Addendum 36: Regulation No. 37

Revision 5 – Amendment 1

Supplement 34 to the 03 series of amendments to the Regulation: Date of entry into force:
19 August 2010

Uniform provisions concerning the approval of filament lamps for use in approved lamp units of power-driven vehicles and of their trailers

Category H16

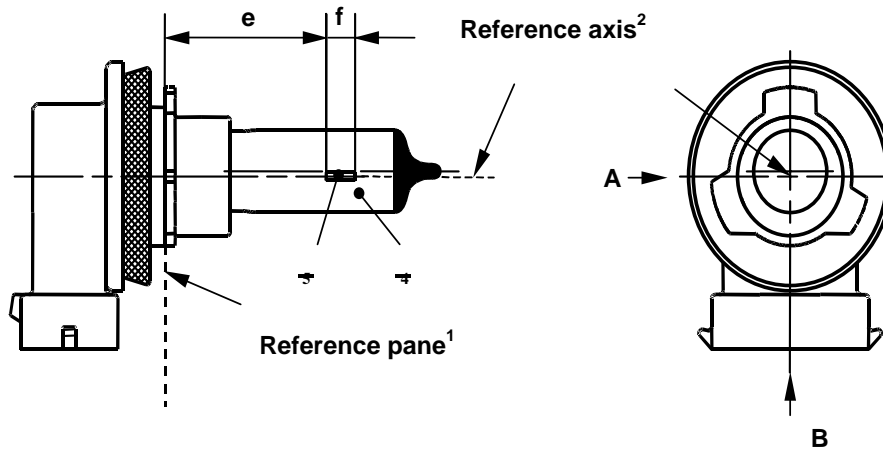
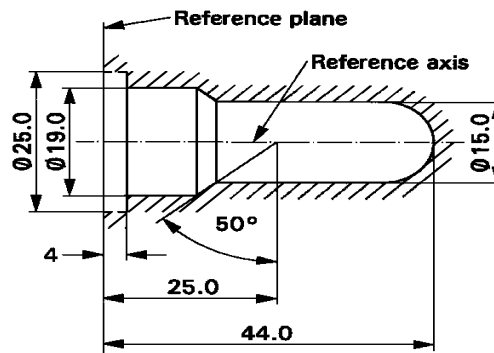
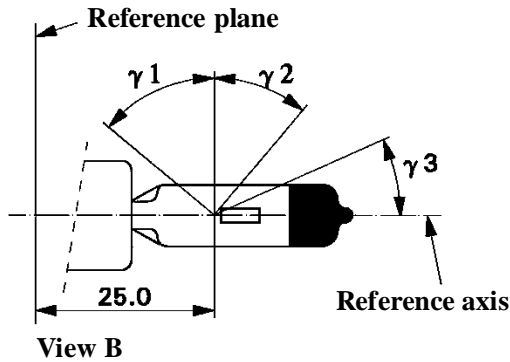
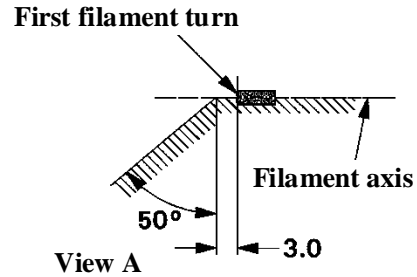
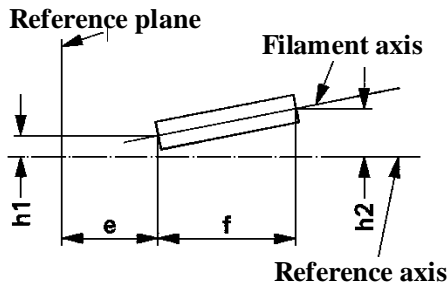
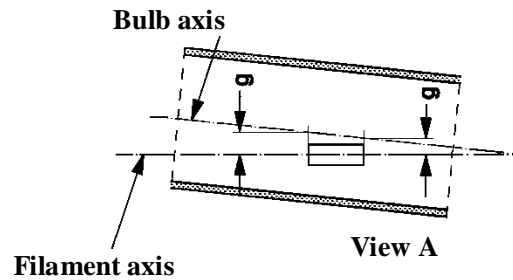
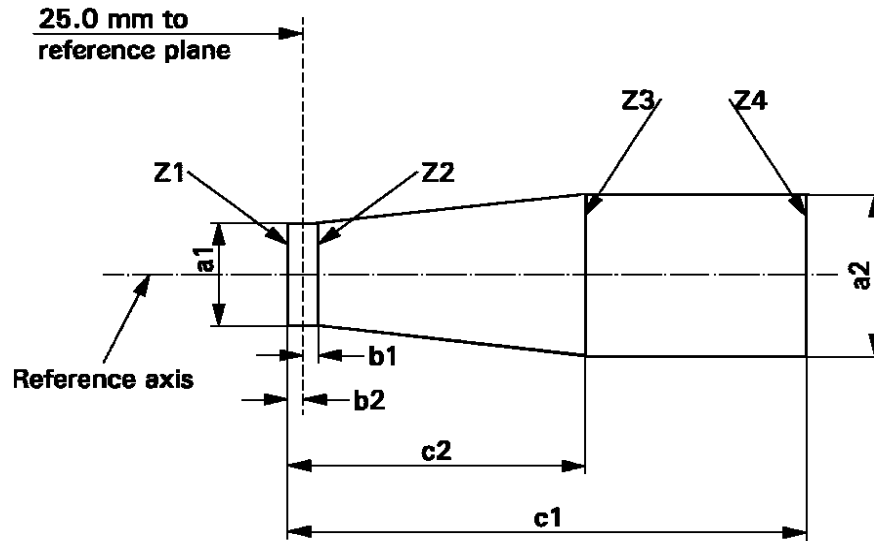
Insert new sheets H16/1 to 4, between sheet H15/5 and H6W/1, to read (see next pages):

Sheet HS5A/1

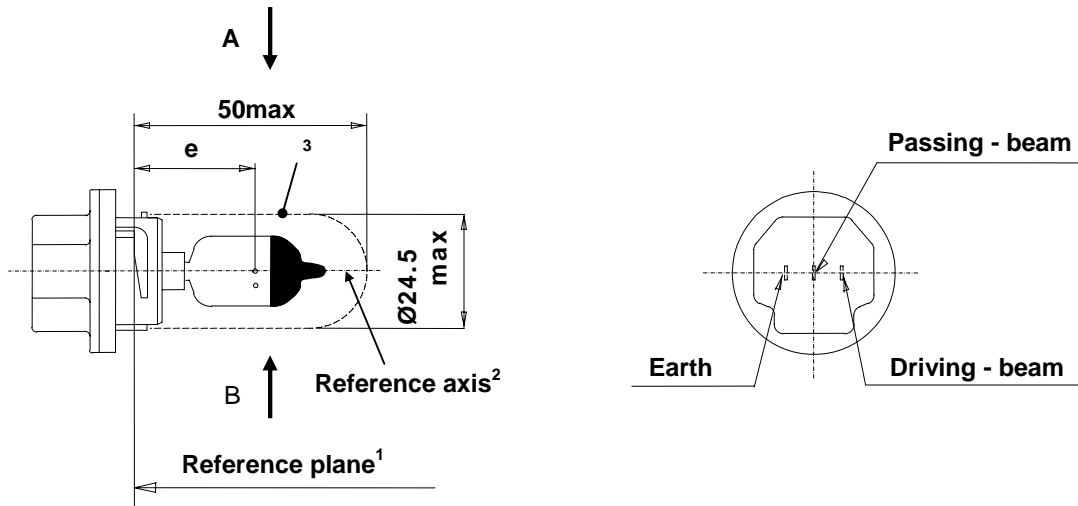
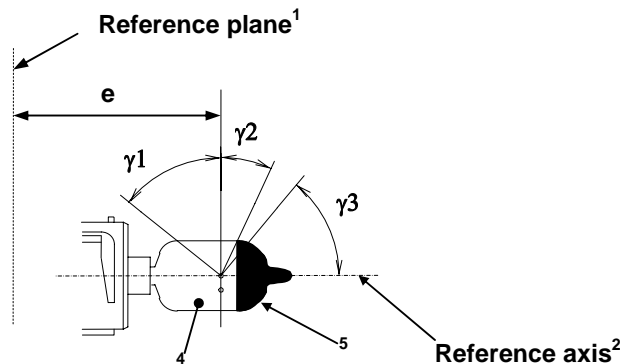
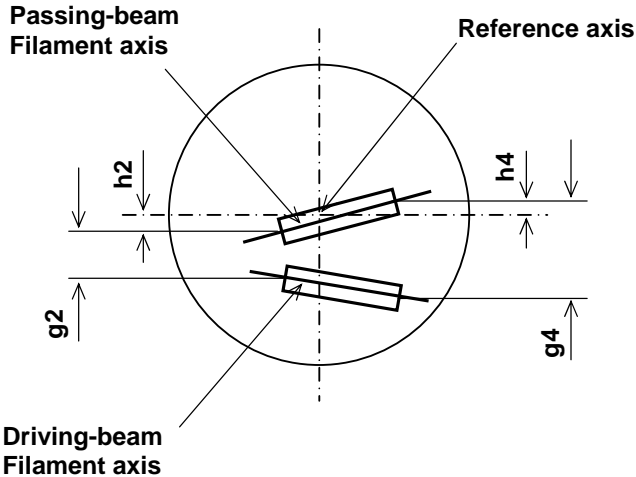
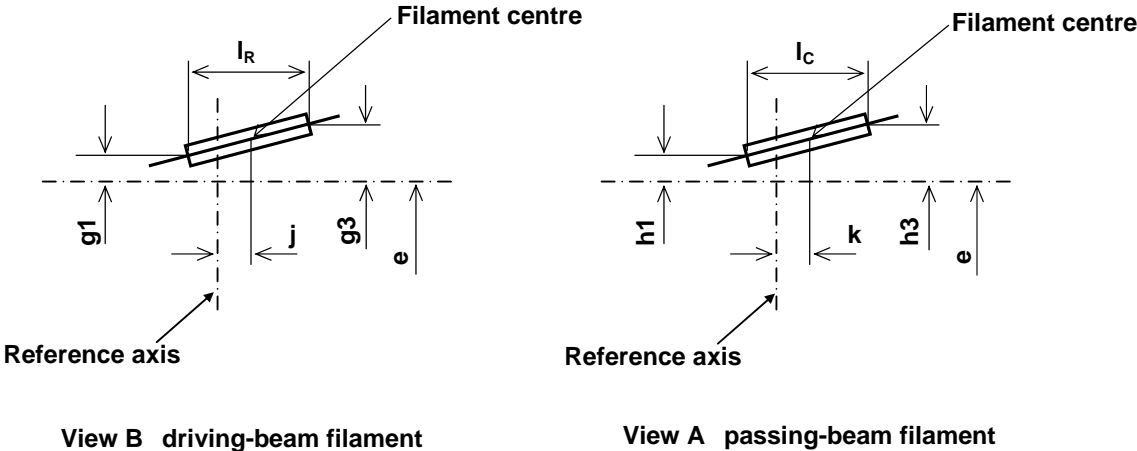
Insert new sheets HS5A/1 to 3, between sheet HS5/4 and sheet HS6/1, to read:

Sheet PSX26W/1

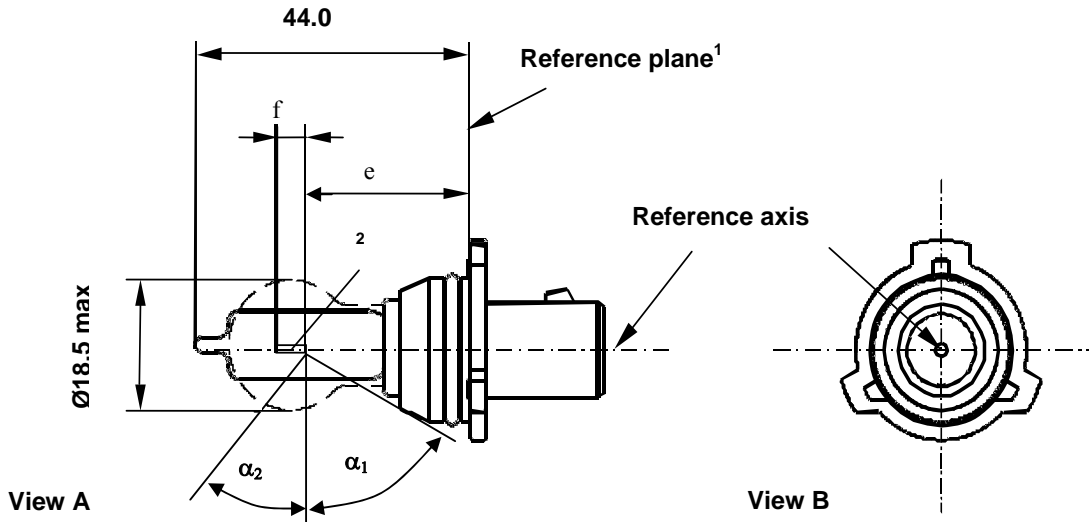
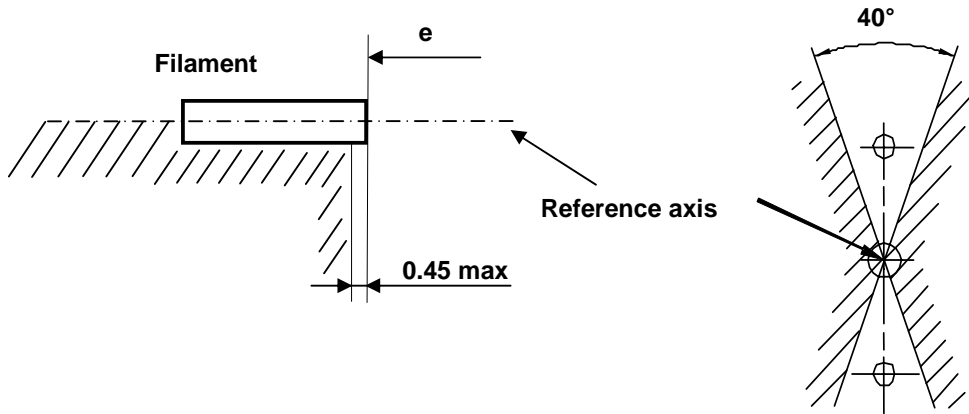
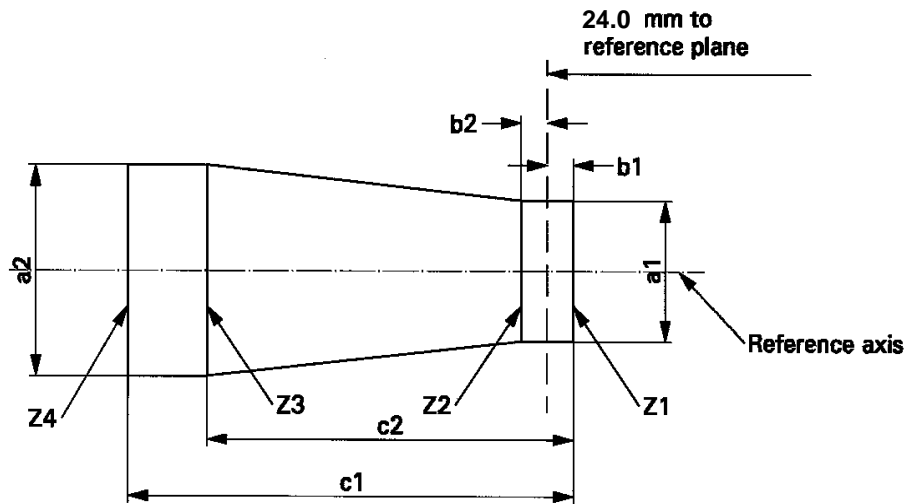
Insert new sheets PSX26W/1 to 3, between sheet PR27/7W/1 and sheet PY21W/1, to read:
